HANGER REPORT

Midland Plant Units 1 and 2

August 9, 1982

- I. INTRODUCTION
 - A. Reason for Overinspection
 - B. Overinspection Results
 - C. Corrective Action and Safety Evaluation of Identified Nonconformances
 - D. Adjusted Reported Results and Dispositions
- II. POTENTIAL GENERIC EVALUATION OF IDENTIFIED NONCONFORMANCES
 - A. Introduction
 - B. Conclusions
 - C. Tables 1 and 2
- III. PROCESS CORRECTIVE ACTION
 - A. Completed Process Corrective Action
 - B. Planned Process Corrective Action
- IV. SUMMARY AND CONCLUSIONS

3B - Anchors (see Figure 3a above):

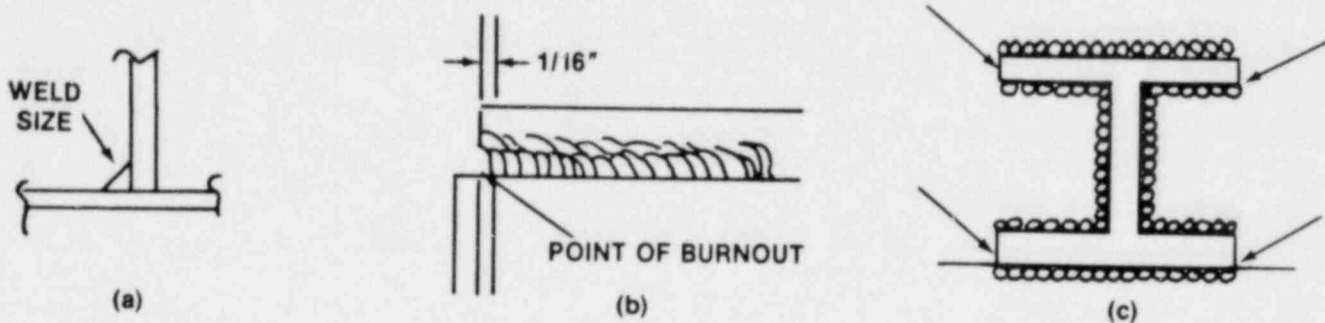
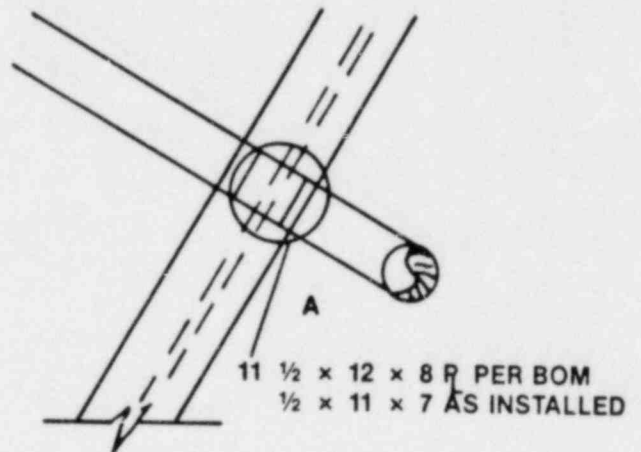
Undersize welds include: a) weld size which is either entirely or partially less than specified in the drawing, b) undercut (burnout), and c) noncontinuous weldment.

<u>Hanger No.</u>	<u>No. of Occurrences</u>	<u>Ref: CPCo NCR</u>
1-610-4-27, Rev 4(b)	1	M-01-9-2-007
2-604-3-18, Rev 1(c)	1	M-01-9-2-007
2-611-7-33, Rev 1(a)	1	M-01-9-2-010
2-611-6-5, Rev 3(a)	2	M-01-5-2-014
2-613-4-19, Rev 3(a)	1	M-01-5-2-014
2-619-6-11, Rev 3(a)	1	M-01-5-2-014
1-612-2-2, Rev 1(a)	1	M-01-5-2-014

<u>Hanger No.</u>	<u>No. of Occurrences</u>	<u>Ref: CPCo NCR</u>
2-619-1-19, Rev 1(a)	1	M-01-9-2-010
1-612-4-33, Rev 1/F1(a)	1	M-01-5-2-014
1-616-6-28, Rev 1(a)	1	M-01-9-2-007

ANOMALY 4: BILL OF MATERIAL PROBLEM

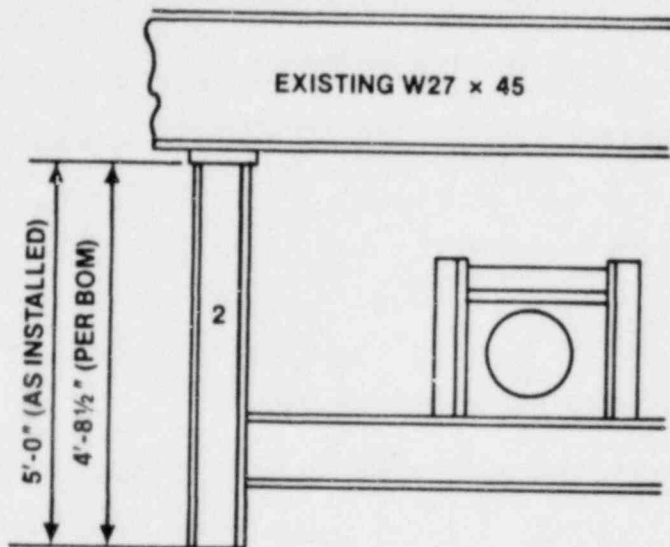
Component dimensions are not in accordance with the dimensions listed on the bill of materials.

<u>Hanger No.</u>	<u>No. of Occurrences</u>	<u>Ref: CPCo NCR</u>
1-616-10-22, Rev 4	1	M-01-9-2-007
FSK-M-2HBC-216-5-H3, Rev 0	1	M-01-9-2-010
2-604-16-15, Rev 0/F1	2	M-01-9-2-010
2-619-1-19, Rev 1	1	M-01-9-2-010
FSK-M-2HBC-219-1-H1, Rev 0	1	M-01-9-2-010
FSK-M-2HBC-144-1-H8, Rev 1	1	M-01-5-2-014
2-619-6-11, Rev 3	2	M-01-5-2-014
FSK-M-2GCB-22-1-H3, Rev 0	1	M-01-5-2-014

5A - Component Supports Other Than Anchors:

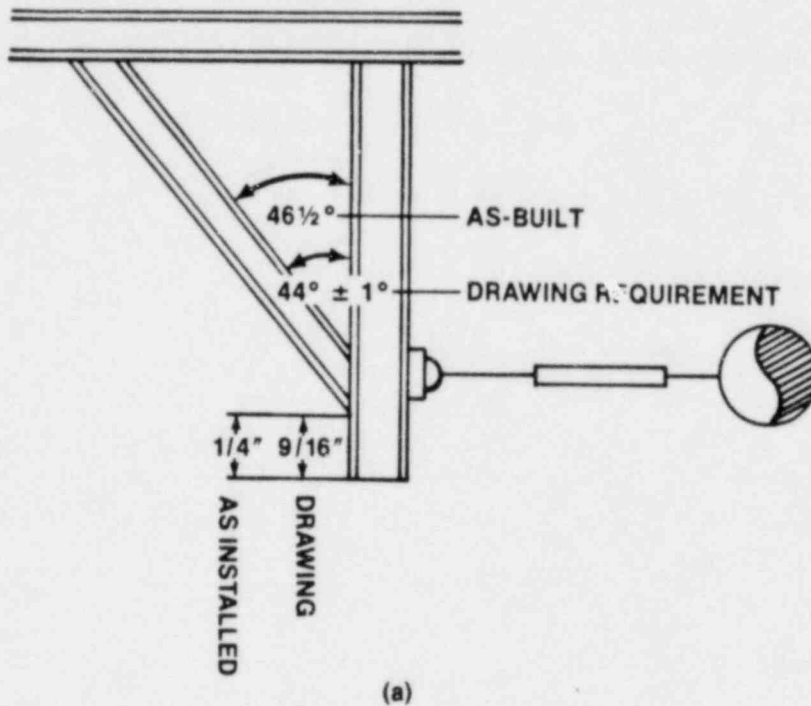
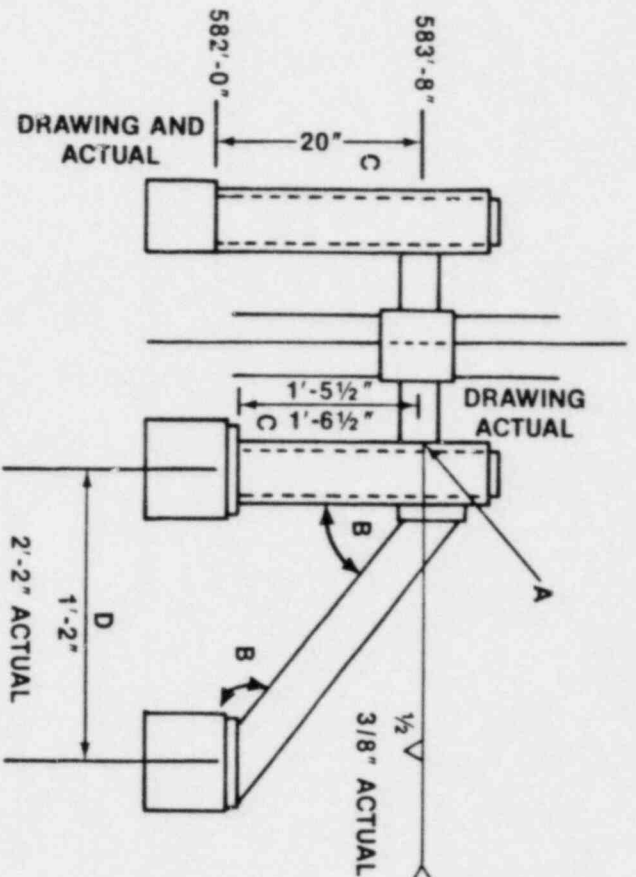
Angular and linear dimensions are not in accordance with the drawing.

<u>Hanger No.</u>	<u>No. of Occurrences</u>	<u>Ref: CCo NCR</u>
2-611-6-5, Rev 3	1	M-01-5-2-014
1-619-14-4, Rev 2	1	M-01-9-2-007
1-610-4-27, Rev 4	1	M-01-9-2-007
1-616-10-22, Rev 4	1	M-01-9-2-007
1-612-2-3, Rev 1	1	M-01-9-2-007
FSK-M-1HBC-219-1-H1, Rev 2	1	M-01-9-2-007
2-616-8-2, Rev 7	1	M-01-9-2-010

<u>Hanger No.</u>	<u>No. of Occurrences</u>	<u>Ref: CPCO NCR</u>
2-611-4-4, Rev 4	1	M-01-9-2-010
2-617-11-9, Rev 0	2	M-01-5-2-014
1-633-1-33, Rev 2	1	M-01-5-2-017

ANOMALY 6: CLEARANCE BETWEEN PIPE AND SUPPORT

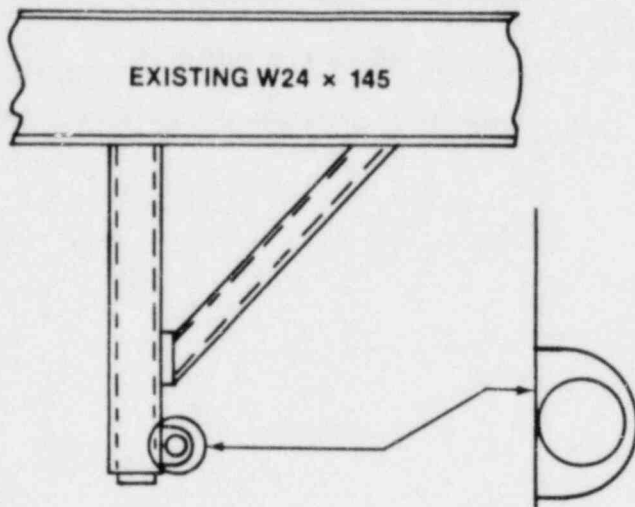
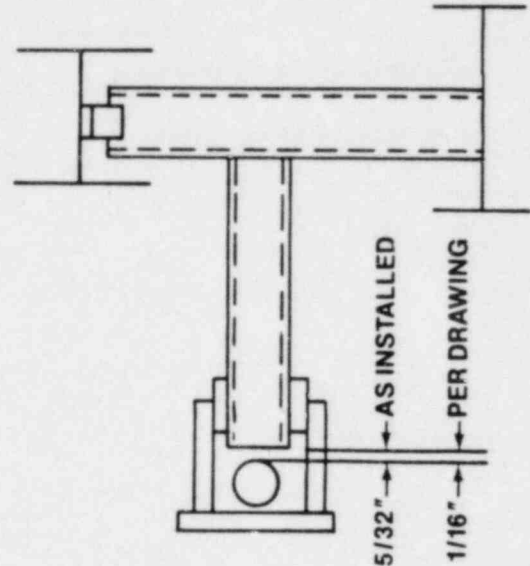
Clearances between pipe and support (strap, u-bolt, box) do not conform to the drawing/specification tolerances, e.g., zero clearance, excessive clearance.

<u>Hanger No.</u>	<u>No. of Occurrences</u>	<u>Ref: CPCo NCR</u>
2-604-16-15, Rev 0/F1(a)	1	M-01-9-2-010
2-657-43-6, Rev 1(b)	1	M-01-9-2-010
2-619-6-11, Rev 3(a)	1	M-01-5-2-014
FSK-M-1HBC-144-1-H3, Rev 1(b)	1	M-01-5-2-017
1-648-7-58, Rev 1/F1(b)	1	M-01-5-2-017
1-657-37-9, Rev 2(a)	1	M-01-5-2-017
FSK-M-0HBC-142-1-H1, Rev 4(b)	1	M-01-5-2-017

ANOMALY 7: FIXED COMPONENT ROTATION

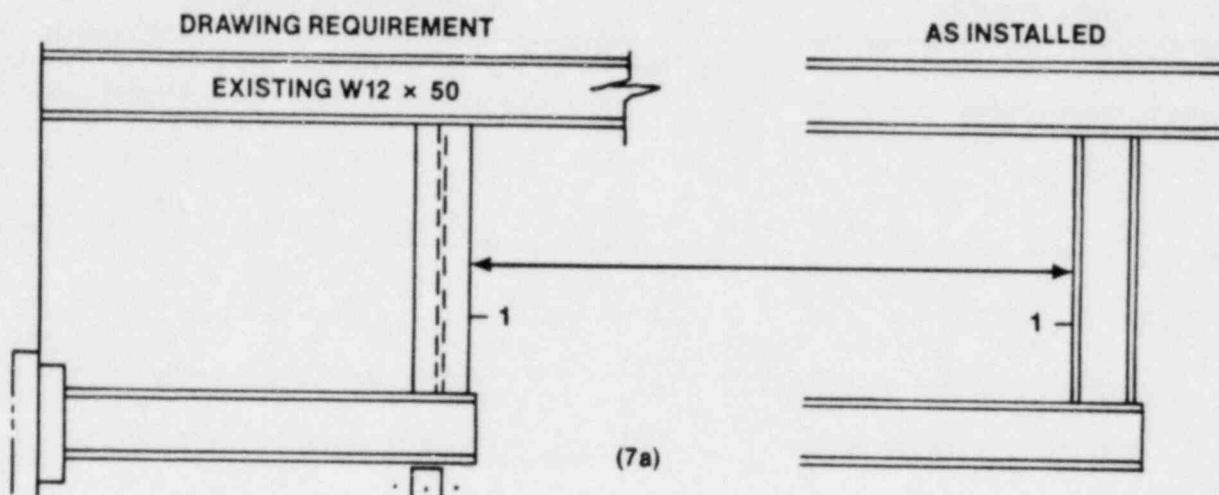
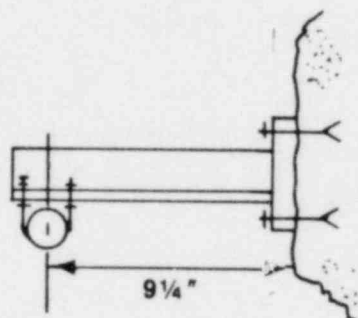
Support member rotated ___ degrees from design sketch.

ANOMALY 8: LOCATION OF HANGERS

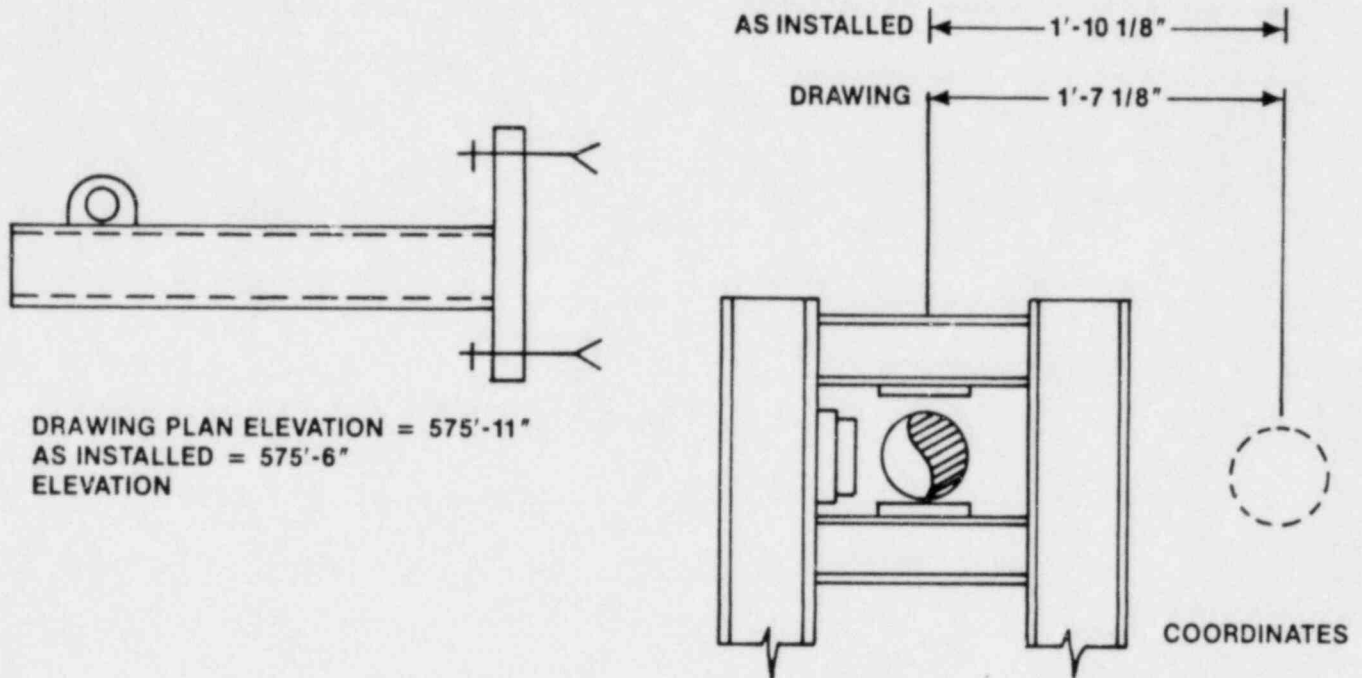
Hangers are not installed in accordance with the elevation and coordinates specified in the drawings. For example:

<u>Hanger No.</u>	<u>No. of Occurrences</u>	<u>Ref: CCo NCR</u>
FSK-M-2HBC-217-1-H2, Rev 1	1	M-01-9-2-010
1-612-2-2, Rev 1	1	M-01-5-2-014
2-619-6-11, Rev 3	1	M-01-5-2-014
1-612-3-12, Rev 1	1	M-01-5-2-014
2-619-1-20, Rev 1	1	M-01-5-2-014

ANOMALY 9: GAP BETWEEN WALL AND BASEPLATE

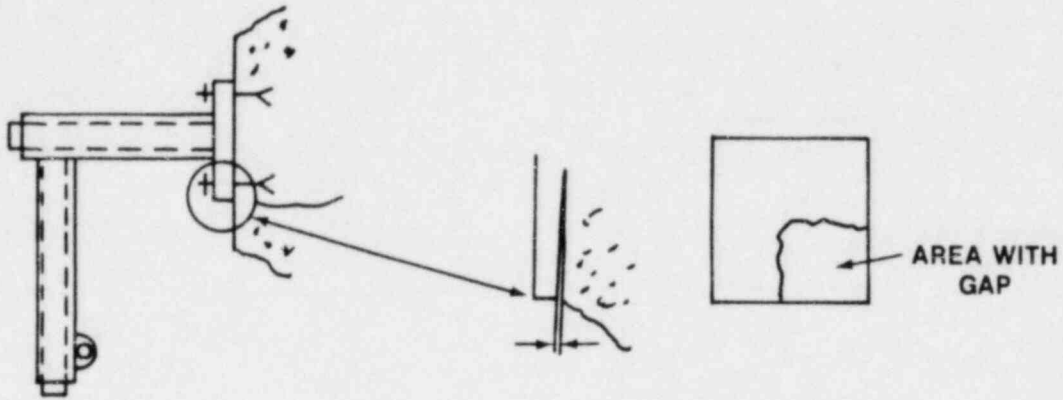
Lower right-hand corner of baseplate exceeds gap tolerance.

<u>Hanger No.</u>	<u>No. of Occurrences</u>	<u>Ref: CCo NCR</u>
FSK-M-2HBC-216-5-H3, Rev 0	1	M-01-9-2-010

ANOMALY 10: CLEVIS ROTATION

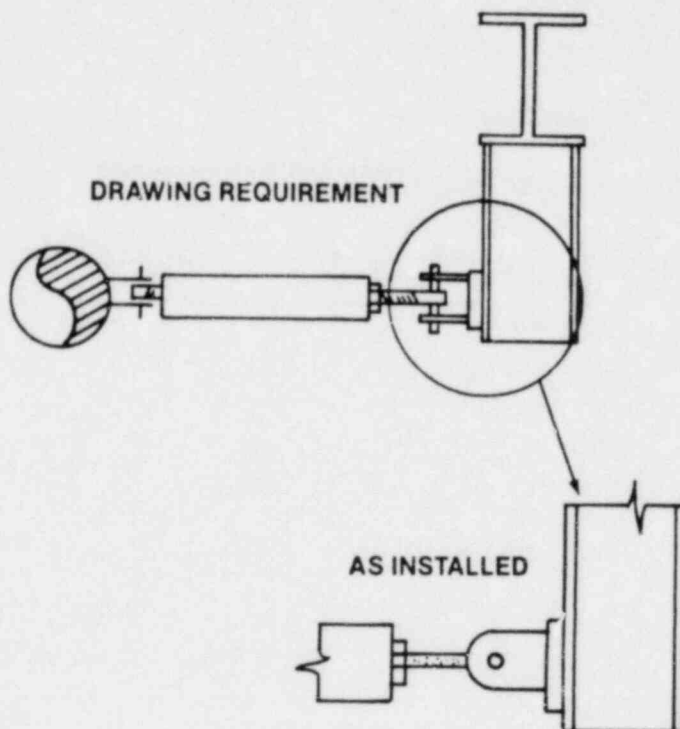
Clevis rotated 90 degrees from drawing configuration.

<u>Hanger No.</u>	<u>No. of Occurrences</u>	<u>Ref: CCo NCR</u>
2-604-2-35, Rev 1	1	M-01-9-2-010
2-619-2-19, Rev 1	1	M-01-5-2-014

ANOMALY 12: WELD IN WRONG PLACE

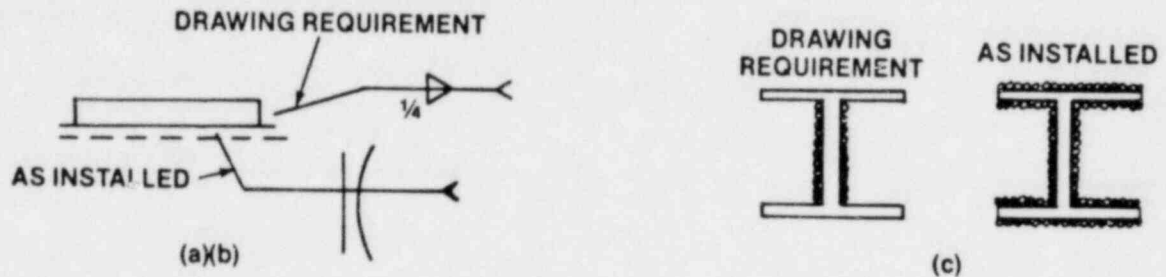
Field welds do not conform to drawing requirements, e.g., a, b) welds located at the ends instead of at the sides, c) weld configuration is not as shown on the drawing.

<u>Hanger No.</u>	<u>No. of Occurrences</u>	<u>Ref: CPCo NCR</u>
0-618-1-6, Rev 0(b)	1	M-01-5-2-017
2-617-8-5, Rev 2(c)	1	M-01-9-2-007
FSK-M-2HBC-219-1-H1, Rev 0(a)	1	M-01-9-2-010

ANOMALY 13: THREAD ENGAGEMENT

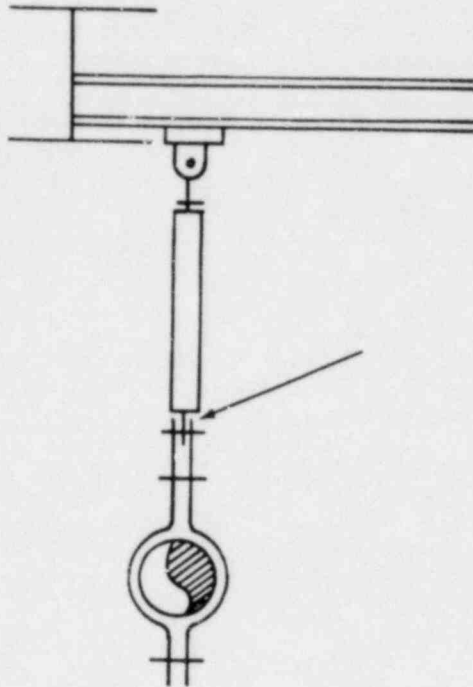
At sight holes of support rod, no threads are visible. Thread engagement (at the lower end only) was 1 inch, instead of 1-1/2 inch.

<u>Hanger No.</u>	<u>No. of Occurrences</u>	<u>Ref: CPCo NCR</u>
1-616-8-2, Rev 7	1	M-01-9-2-010

BASED ON CARDS, 1" THREAD ENGAGEMENT IS SUFFICIENT. SUGGEST TO REMOVE F14211 TO MEET IT-G'S INSTALLATION REQUIREMENTS. R.M. 4/28/82
IT-G.

ANOMALY 14: MISCELLANEOUS

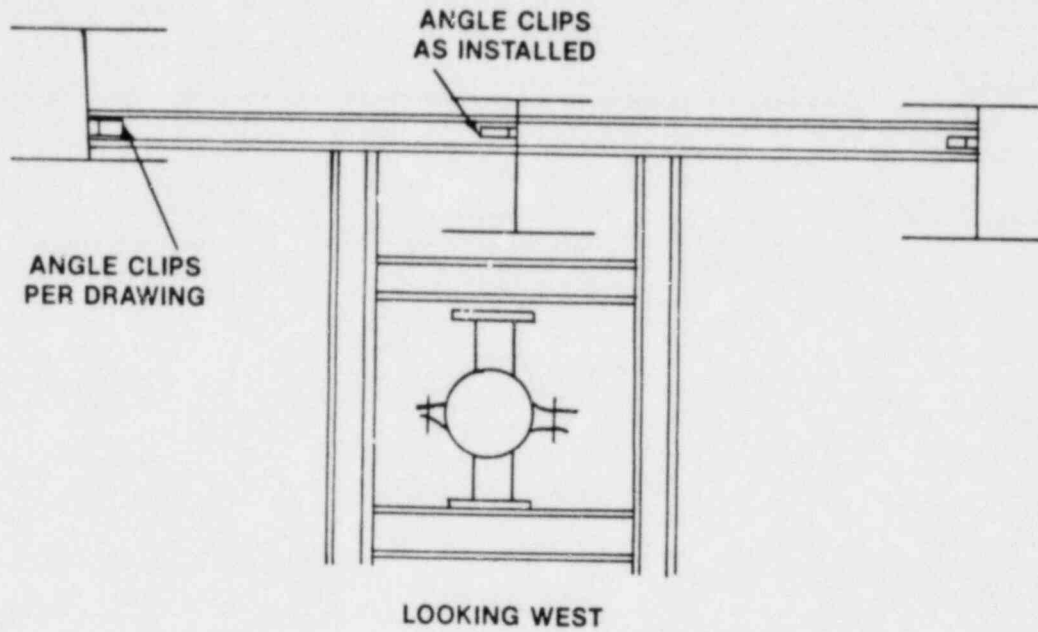
Angle clips are in wrong location.

Hanger No.
0-617-7-13, Rev 0
